THE BUSINESS CASE FOR AN ACCESSIBLE EVERGREEN

MOREHEAD-CAIN ACCESSIBILITY TEAM
July 2019

AODA & TORONTO ACCESSIBILITY DESIGN GUIDELINES

COMPLIANCE REPORT

Figure 24

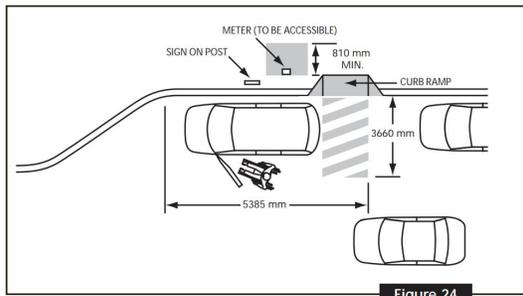
1.2.5 Parking	<ul style="list-style-type: none"> ● 1.2.5.3 There are only 2 accessible spaces in the central parking lot of 129 spaces. Under AODA guidelines: 4 spaces are required for 100 spaces, and 1 accessible space for each additional 25 spaces 	Central Parking Lot
	<ul style="list-style-type: none"> ● 1.2.5.4 The accessible parking spaces in the central parking lot are not wide enough (2500 mm each) <ul style="list-style-type: none"> ○ Need at least 1 space that is 3660 mm wide 	Central Parking Lot
	<ul style="list-style-type: none"> ● 1.2.5.0 Existing spaces are greater than 30m away from the Garden Market and Belong Cafe entrances <ul style="list-style-type: none"> ○ Parking spaces should be a maximum of 30m from main building entrances 	Central Parking Lot
	<ul style="list-style-type: none"> ● 1.2.5.9 The accessible parking spaces are not clearly marked with the “International Spot of Accessibility,” (e.g., with a paving sign and a post mounted sign) <ul style="list-style-type: none"> ○ The symbol should be repainted as markings are faded 	Central Parking Lot

- a. (AODA Guidelines, Page 14)
5. At least one accessible parking space for wheelchair vans, a minimum of 3660 mm wide and 5385 mm long, should be provided for each 100 spaces. (See Figure 24)

Figure 27

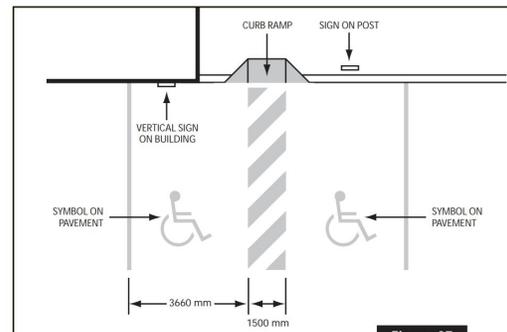
<ul style="list-style-type: none"> ● 1.2.5.9 The accessible parking spaces are not clearly marked with the “International Spot of Accessibility,” (e.g., with a paving sign and a post mounted sign) <ul style="list-style-type: none"> ○ Should be repainted as markings are faded and indistinguishable ○ Of the 2 spots side-by-side, the left spot did not have a sign on the post 	West Parking Lot (Signage) West Parking Lot (Faded Paint)
	<ul style="list-style-type: none"> ● 1.2.5.3 There are only 3 accessible spaces in the West Parking Lot (100 spaces). Under AODA guidelines: 4 spaces are required for 100 spaces, and 	West Parking Lot

1. Parking meters to be accessible for persons with disabilities.
 - a. (AODA Guidelines, Page 14)
2. All accessible parking spaces should be marked with the “International Symbol of Accessibility”, (e.g., with a paving sign and a post mounted sign). (See Figures 26 and 27)

Figure 47

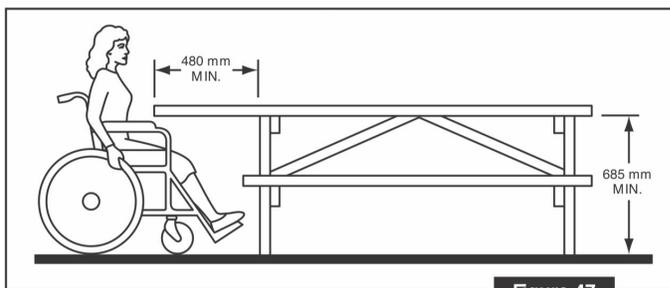
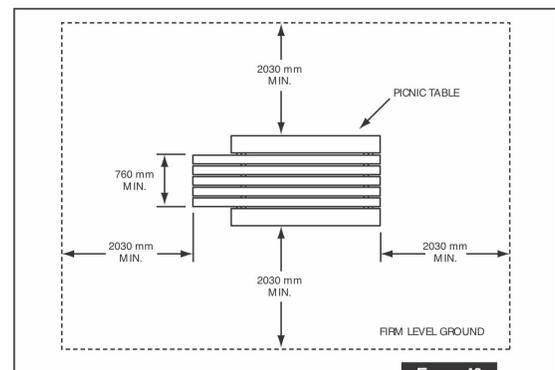
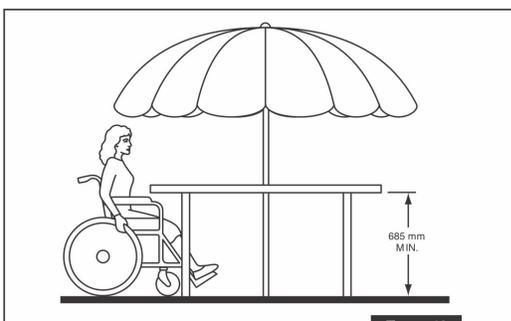
1.3.11 Picnic Areas	<ul style="list-style-type: none"> ● 1.3.11.3 There are no picnic benches at EBW that are designed for wheelchair accessibility 	General Campus

1. The design of picnic tables should allow persons using mobility aids to approach them from one or both ends and provide adequate knee and armrest clearance. (See Figures 47, 48 and 49)

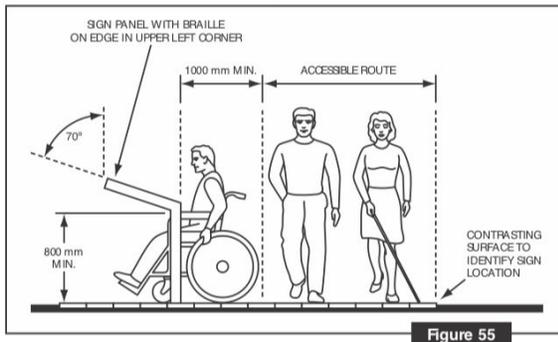
1.3.3 Boardwalks	<ul style="list-style-type: none"> ● 1.3.3.2 Planking on footbridges and boardwalks is not consistently perpendicular to direction of travel with gaps in between planks too wide 	Weston Family Quarry Garden and Don Valley Brick Works Park

1. Boardwalk surfaces should be of firm, non-slip materials. Where wooden boardwalks are provided, planks should be laid perpendicular to the normal path of travel with joint widths no greater than 6 mm.

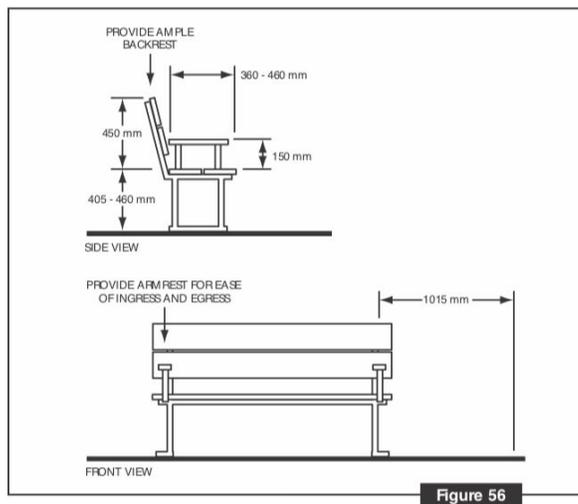
1.4.1 Benches and Seats	<ul style="list-style-type: none"> ● 1.4.1.2 Benches outside of the Gradale Academy building were 350 mm in height instead of the required 405 mm 	Gradale Academy/Outward Bound building
	<ul style="list-style-type: none"> ● 1.4.1.2 Built-in benches on the Frances and Price Terrace were 500-510 mm in height exceeding the 460 mm maximum 	Frances and Price Terrace

- 1. Fixed benches should include suitable back supports and arms to allow for easy transfers, with a seat height between 405 mm and 460 mm. (See Figure 56)
 - a. (AODA Guidelines, Page 30)

Figure 71

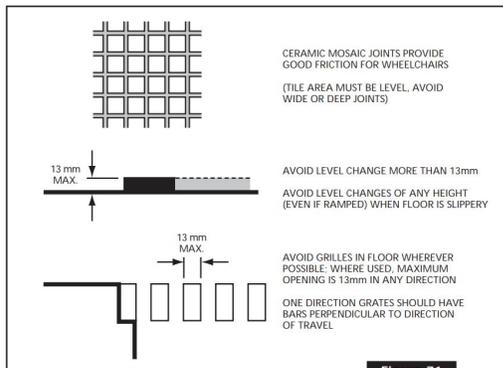
1.6.1 Colour and Texture	<ul style="list-style-type: none"> ● 1.6.1. Figure 71 Grates are parallel to the direction of travel rather than perpendicular. The width of single grate is too wide (25.4 mm) compared to the required 13 mm 	Sidewalk outside of Evergreen Garden Market

- 1. Figure 71: Avoid grilles in floor wherever possible; where used, maximum opening is 13mm in any direction. One direction grates should have bars perpendicular to direction of travel.
 - a. (AODA Guidelines, Page 40)

Figure 73

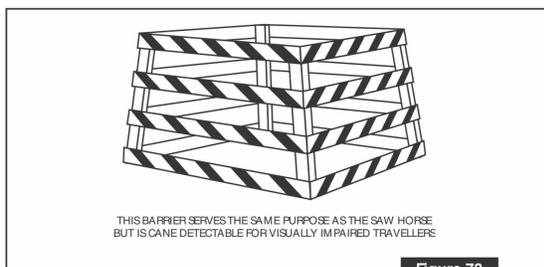
1.6.2 Construction Site Protection	<ul style="list-style-type: none"> ● 1.6.2.4 The boundaries between construction sites and pedestrian traffic are unclear and lack cane detectable temporary barriers. <ul style="list-style-type: none"> ○ The site may be hazardous to those with visual limitations 	Construction at the north end of The Pavilions

1. Cane detectable temporary barriers should be provided around all short-term repair sites (e.g. sidewalk repairs, manhole access covers etc.), as an aid to persons who have visual limitations. (See Figure 73)
 - a. (AODA Guidelines, Page 41)

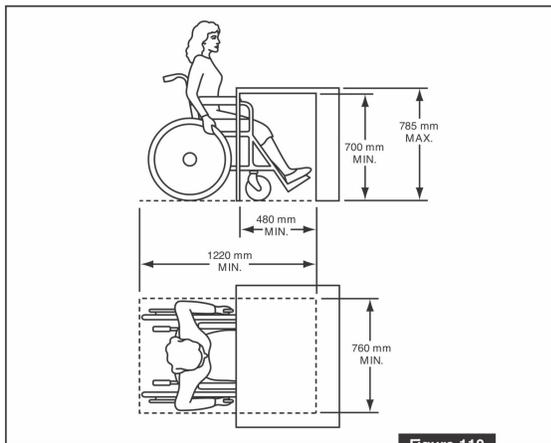
2.2.1 Aisles and Passages	<ul style="list-style-type: none"> ● 2.2.1.2 Most passageways are less than the minimum width required by the AODA to accommodate users with mobility aids. Most aisles are between 900mm-1076mm wide when the required width is 1100mm <ul style="list-style-type: none"> ○ Suggestions for Exceeding Compliance 	Evergreen Garden Market
	<ul style="list-style-type: none"> ● 2.2.1.2The aisles in this room do not meet the minimum AODA requirement (1100 mm wide). The aisles are 762 mm (left) and 939 mm (right) wide 	Centre for Green Cities-The Clubhouse Room

1. In low use areas and offices etc., clear aisle space and passageways between walls, glazed screens, furniture and/or other major obstacles should be a minimum of 1100 mm to accommodate users of mobility aids.
 - a. (AODA Guidelines, Page 59)

Figure 137

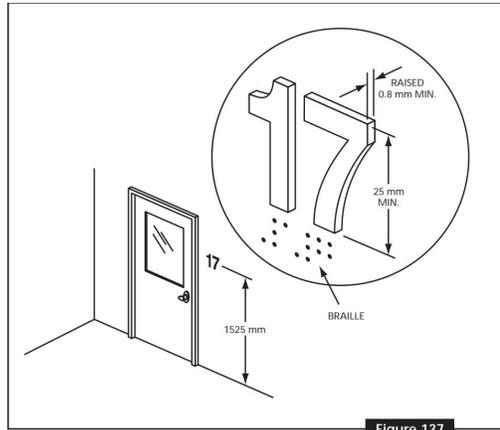
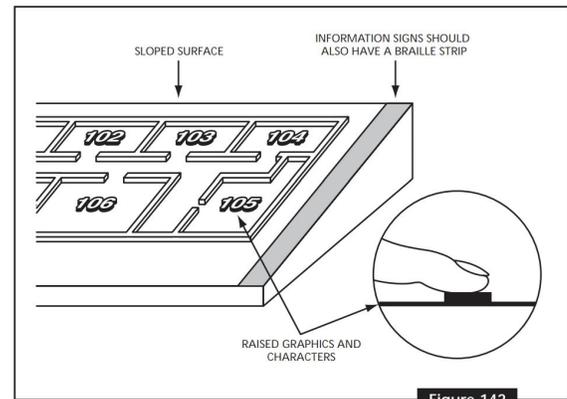
2.4.16 Signage and Way-finding	<ul style="list-style-type: none"> ● 2.4.16.6 The main lobby should provide a tactile map of the campus, or a tactile version of the available campus maps 	Young Welcome Centre
	<ul style="list-style-type: none"> ● 2.4.16.5 All signs and informational or educational displays should have available braille and/or audio alternatives <ul style="list-style-type: none"> ○ Only bathroom signs in the Young Welcome Centre followed guideline 	EBW Campus Signage

1. For Braille users, braille information should be located immediately below all room numbers and names, as well as below any major directional signs. (See Figures 137 and 142)

Figure 148

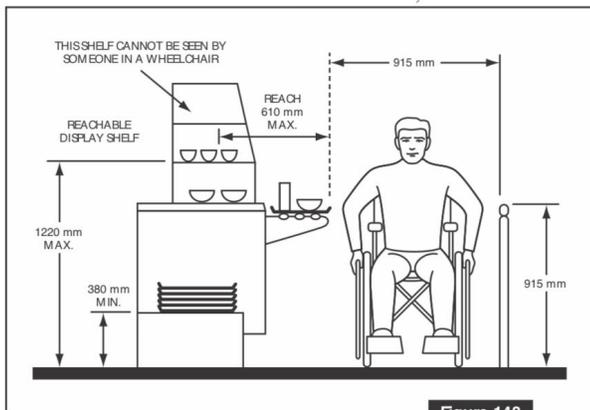
2.5.3 Cafeterias, Restaurants, Dining Areas and Bars	<ul style="list-style-type: none"> ● 2.5.3.4 The counter height of Cafe Belong is too tall (924 mm) when the maximum is 915 mm 	Cafe Belong

1. Where counter service is provided, at least one section of the counter should be no higher than 915 mm by 760 mm wide, to allow a person using a wheelchair or scooter to approach. (See Figure 148)
 - a. (AODA Guidelines, Page 90)
